Access Compliance Report Public Rights-of-Way (Curb Ramps)

Intersection ID: 18381 Main Street: BATHURST DR **Cross Street: WYALONG DR** Location: SE **ADA ID: 8F9E64EBC7E3** Ramp Type: BlendTrans1 Initial Pass/Fail: Pass **Overall Compliance: No Severity Score:**

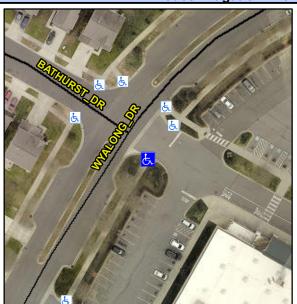
Possible Solutions: Compliance Description Remove & Replace Landing. N/A Yes N/A Surveyor Notes: N/A PROW/ADA: R304.2.2-Perp, R304.3.2-Para

11//	riare Type Er	Ciopca	14/7	riare rypertr	Olopea
N/A	Flare Slope LT (%)	3.3	N/A	Flare Slope RT (%)	5.0
N/A	Flare Traversable LT?	No	N/A	Flare Traversable RT?	No
Yes	Landing Length (in)	53.0	Yes	DWS Provided?	Yes
Yes	Landing Width (in)	48.0	Yes	DWS Contrast?	Yes
No	Landing Slope (%)	2.5	Yes	DWS Length (in)	24.5
Yes	Landing X Slope (%)	1.6	Yes	DWS Full Width?	Yes
N/A	Landing Curb? (Y/N)	No	Yes	DWS Offset (in)	0.0
N/A	Shared Landing?	No			
Yes	Gutter Ponding?	No	Yes	Gutter Slope (%)	2.2
Yes	Gutter Lip Ht (in)	0.0	Yes	Gutter X Slope (%)	1.6
N/A	Painted X Walk1?	No	N/A	Painted X Walk2?	N/A
	X Walk 1 Direction	To NE		X Walk 2 Direction	N/A
	X Walk 1 Width (in)	N/A		X Walk 2 Width (in)	N/A
	X Walk 1 Slope (%)	1.1		X Walk 2 Slope (%)	N/A
	X Walk 1 X Slope (%)	0.7		X Walk 2 X Slope (%)	N/A
N/A	Ramp inside XWalk1?	N/A	N/A	Ramp inside XWalk2?	N/A
	Road Slope (%)	0.7		Clear Space?	Yes
	Road X Slope (%)	1.1	N/A	Clear Space to XWalk (in)	N/A
